TITLE: "Drinking Container"

**PETITION FOR RECONSIDERATION OF WHETHER APPLICANT'S BRIEF
COMPLIES WITH 37 CFR 1.192**

**Notification of Non-Compliance
With 37 CFR 1.192(c)**

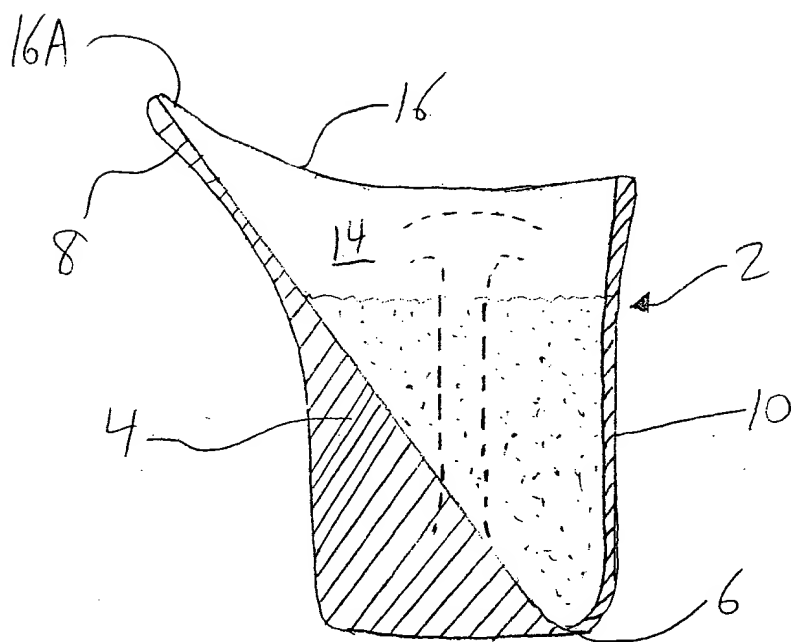
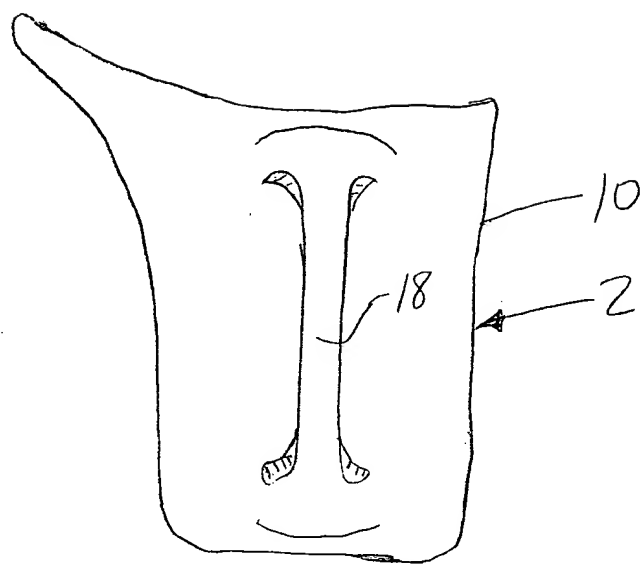
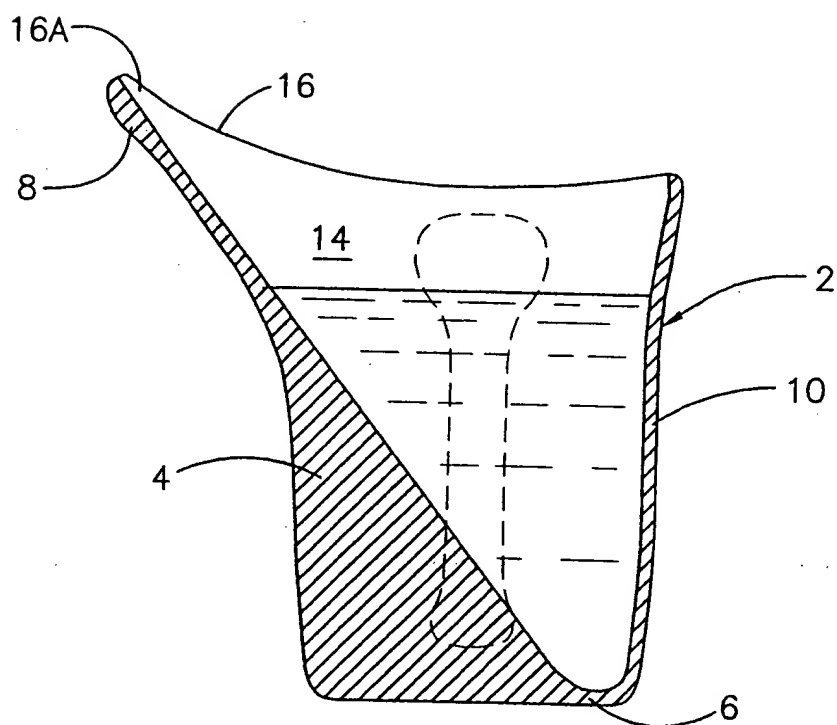
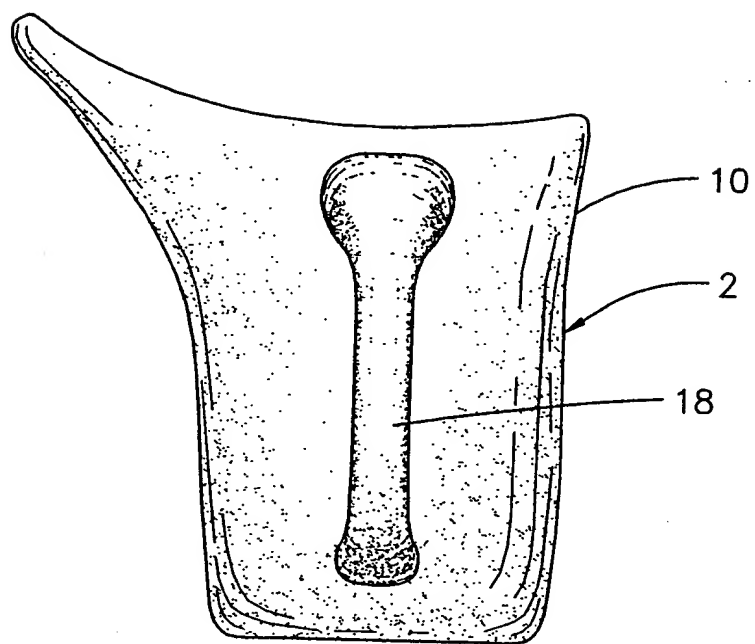
Examiner's statement	Applicant's response
"The original disclosure does not support	The handles shown in formal drawing

the showing of a different shaped handle as shown in Fig. 1A and 1B,” “	Figures 1A and 1B are not significantly different from the original draft drawing Figures 1A and 1C. Any differences are not patentable distinctions; they are merely minor design modifications that were made by the professional draftsman who applicant hired to prepare his formal drawings.
“a differently shaped bottom as shown in Fig. 1C,”	The bottom of the cup shown in formal drawing Figure 1C is not significantly different from the original draft drawing Figure 1C. Any differences are not patentable distinctions; they are merely minor changes in shape and proportion that were made by the professional draftsman who applicant hired to prepare his formal drawings.
“different creases as shown on the interior of the fluid diverter, flow channel and spout in Figure 2B and as shown on the exterior of Fig. 2A near spout 8, etc.”	<p>The items shown in applicant’s original draft drawings are not “creases.” They are representative markings that were intended to indicate the curvature or contour of the flow channel 12. The professional draftsman who prepared applicant’s formal drawings replaced the contour lines of the original drawing with stippling, a technique that is widely used to show contours in patent drawings.</p> <p>This curvature is clearly described in the specification at page 10, lines 4-5: “In the preferred embodiment shown in Figure 1C, the flow channel comprises a lengthwise groove formed by a pair of curved walls.”</p>

For the foregoing reasons, the modifications that the Examiner objects to do not constitute the addition of new matter. All of the features shown in the formal drawings were included in the original draft drawings and in the original specification. The changes are merely minor design modification or changes in drawing technique that were made by the draftsman who prepared the formal drawings. If all applicants were held to the standards that the present applicant is being held to, attempts to replace informal

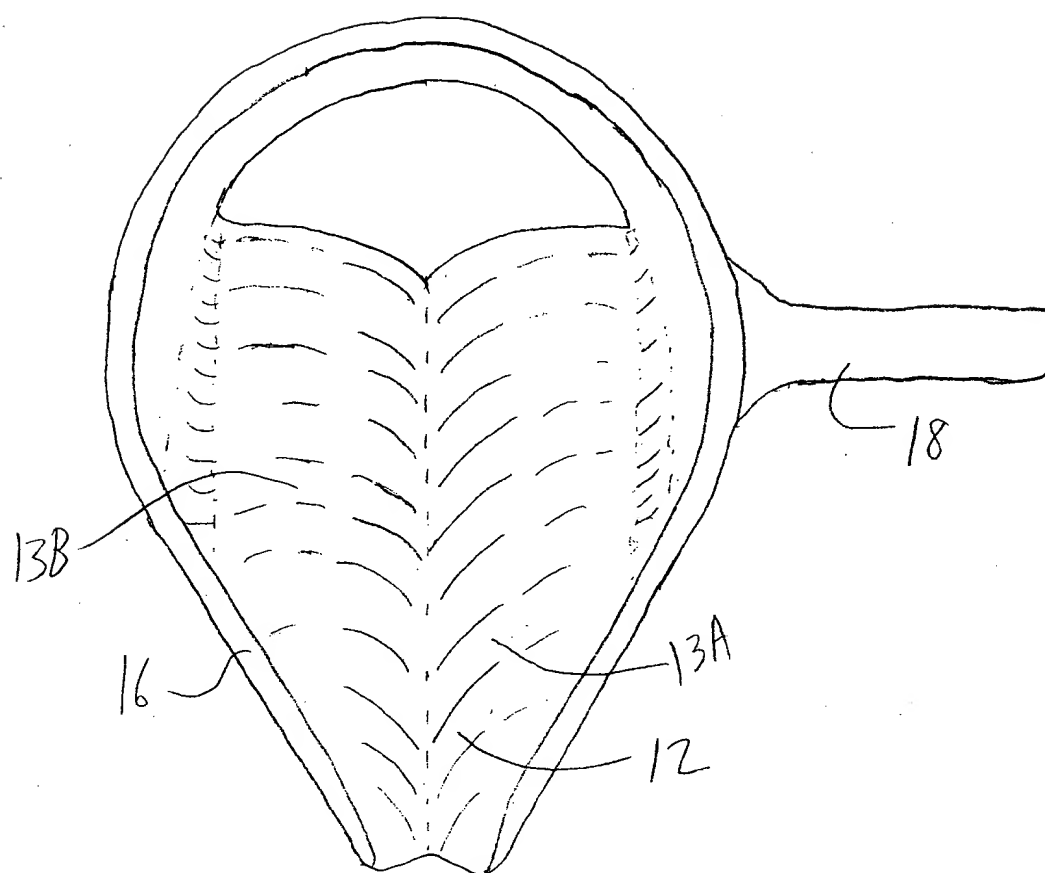
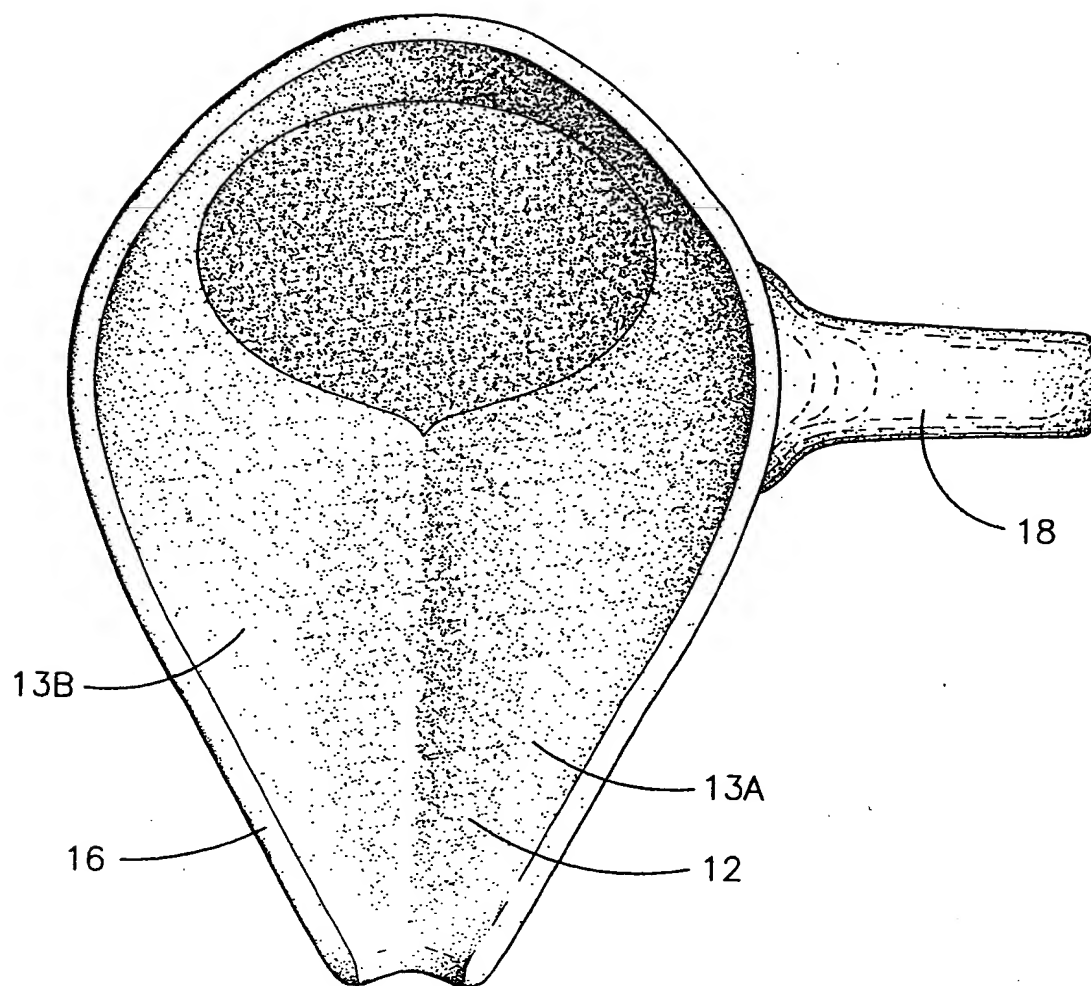
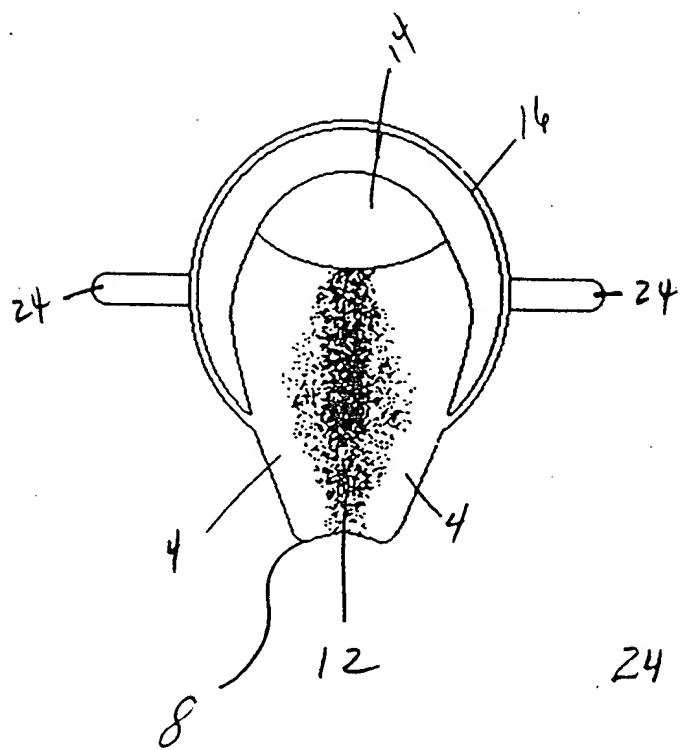
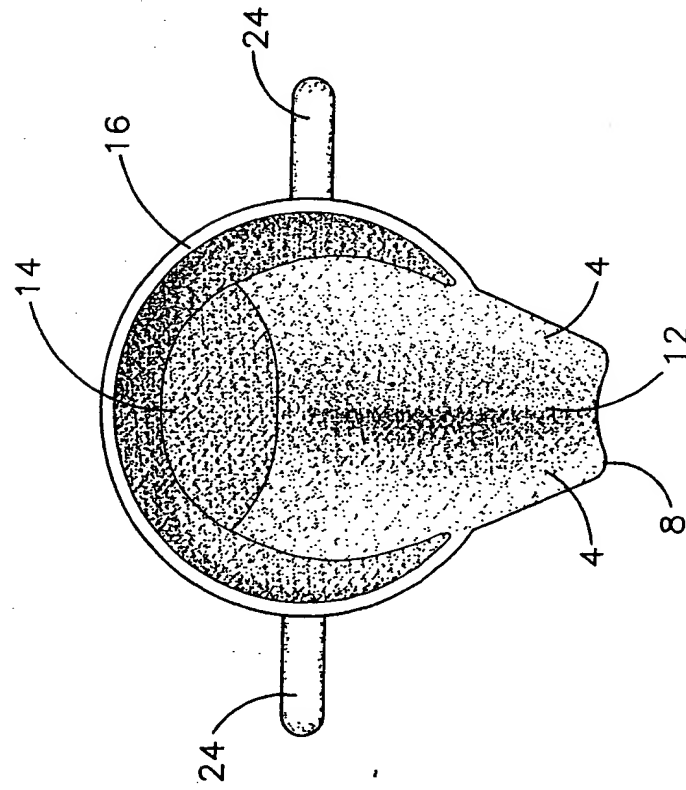
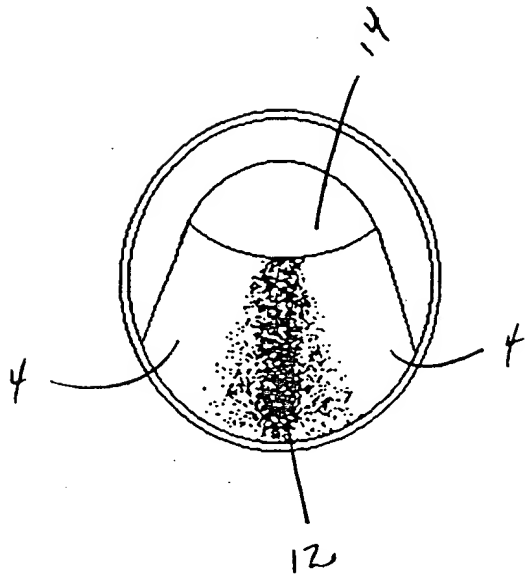
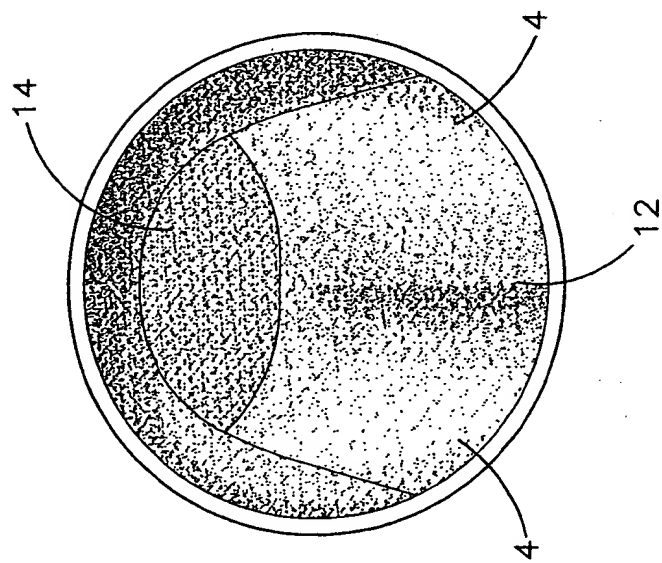
The drawings are objected to as not showing a flow channel 12 extending along an outer surface of the fluid diverter member 4 as stated in claims 3 and 8. Appellant is of the view that the Commissioner's November 18, 2002 Decision on appellant's petition resolved any issues concerning the drawings, including this issue, which was specifically addressed in appellant's petition. The Commissioner concluded that appellant's drawings were acceptable and were to be entered.

Figures 1C, 2B and 3B show the flow channel 12 extending along an outer surface of the fluid diverter member 4. The following excerpt from pages 9-10 of appellant's application fully explains the features in question:

The examiner has taken the position that the drawing objection can be resolved by changing the word "outer" in line 2 of claim 3 to "inner" or "upper" and by changing the word "outer" in line 12 of claim 8 to "inner" or "upper." (Page 3) Appellant has declined to make the change. As explained in further detail with regard to Issue 2, there is a very good reason why appellant has chosen to call the area in question an "outer" surface, rather than an "inner" or "upper" surface.

The examiner's proposed change in claim terminology is immaterial to whether the drawings show the claimed subject matter. There is no question whatsoever that the drawings clearly and unambiguously show a flow channel 12 extending along an outer surface of the fluid diverter member 4. Appellant's petition on this issue has been granted by the Commissioner, and it is accordingly respectfully suggested that it should no longer be raised as a ground of objection.

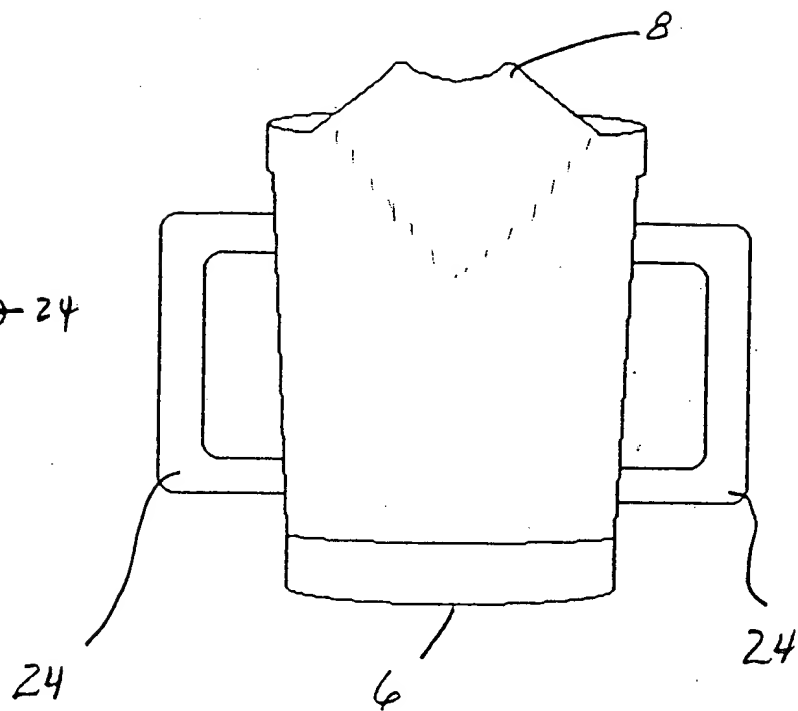
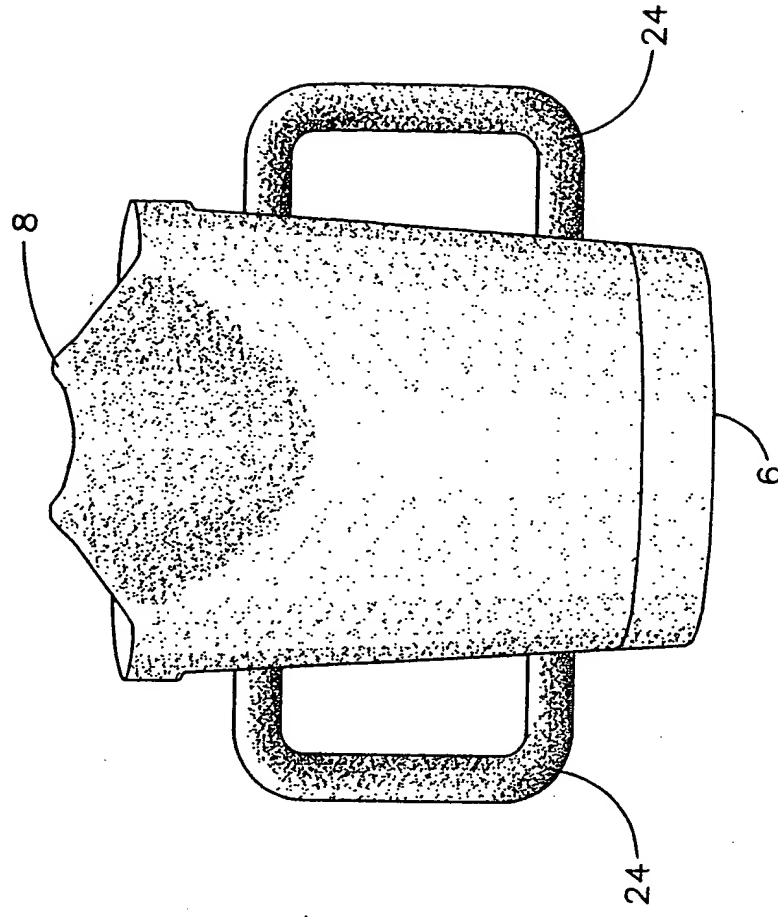
In paper No. 5, the examiner, opined that Figures 2A and 2B "do not show a wedge shaped fluid diverter as claimed in claims 2 and 8-10, do not show a flow channel extending lengthwise along an outer surface of said fluid diverter member as claimed in claims 3 and 8-10 and do not show an extension spout as claimed in claims 6 and 8-10." The examiner accordingly held that claims 2, 3, 6 and 8-10 did not read on the elected species, and that only claims 1, 4 and 5 read on the elected species. The examiner proceeded to act only on claims 1, 4 and 5.

Examiner's statement concerning applicant's drawings	Applicant's response
"The fluid diverter 4, flow channel 12 and spout 8 are all located on substantially the same surface and these elements have no specific delineation to separate these elements as shown in Fig 2B."	Patent drawings routinely include a main component (here, the fluid diverter 4) that has subcomponents formed thereon (here, the flow channel 12 and the spout 8). The relationship of these three components to one another is clearly described at page 9, line 16 – page 10, line 10 of the specification. Applicant does not understand the basis of this objection, nor how it would be possible to comply with it.
"The elected specie of Fig. 2A and 2B do not show a wedge shaped fluid diverter as claimed in claims 2 and 8-10 . . ."	<p>The wedge shaped configuration of the fluid diverter member is shown in the cross-section view of Figure 1A. See specification p. 8, lines 14-15; see also Figures 3A and 4A. The top view shown in Figure 2B includes a fluid diverter member 4 that is wedge shaped.</p> <p>If the examiner is taking the position that due to applicant's election, figures other than Figs. 2A and 2B cannot be relied upon as showing claimed features,</p>

this is clearly incorrect. Applicant elected claims 1-10, not the species of Fig. 2A and 2B.
"the fluid diverter (4) is shown but an elevation cross-section is not shown to provide details of a wedge shape, . . ."	An elevation cross-section of the wedge shape is shown in Figure 1A, 3A, and 4A.
"[The drawings] do not show a flow channel extending lengthwise along an outer surface of said fluid diverter member as claimed in claims 3 and 8-10, . . ."	In Figures 1C, 2B, and 3B, the flow channel 12 is shown extending lengthwise along an outer surface of the fluid diverter member 4.
"a flow channel (12) is shown but it extends along an inner surface not an outer surface (the inner surface is contiguous with the fluid diverter (4)) . . ."	In the specification at page 9, line 19- page 10, line 2, applicant states, "As shown most clearly in Figure 1C, the flow channel 12 preferably extends lengthwise along an <i>outer</i> surface of the fluid diverter member 4." The applicant is free to be his own lexicographer, and in this case the applicant is simply using the word "outer surface" to refer to the outer surface of the fluid diverter 4 that is exposed on the inside of the cup. Applicant does not understand the significance of the examiner's comment that "the inner surface is contiguous with the fluid diverter (4)."

"do not show an extension spout extending upward and outward from the upper rim as claimed in claims 6 and 8-10 where the upper rim has an opening through at least a sipping region."	These items are clearly shown in Figures 1A, 1B, 1C, 2A, and 2B. The relationship and location of these items are described at page 10, lines 6-10: "The drinking container shown in Figure 1 includes an extension spout 8 extending upward and outward from the upper rim 16. The sipping region 16A is formed on the upper end of the extension spout 8. As shown in Figure 1, the extension spout 8 is contiguous with the fluid diverter member 4 to thereby assist the fluid diverter member 4 in compelling fluid through the sipping region 16A."
"The drawings are objected to under 37 CFR 1.83(a). The drawings must show every feature of the invention specified in the claims. Therefore, the flow channel extending lengthwise along an outer surface of the fluid diverter member as stated in claims 3 and 8-10 must be shown or the feature(s) canceled from the claims."	For the reasons set forth above, the flow channel is clearly shown in the drawings.
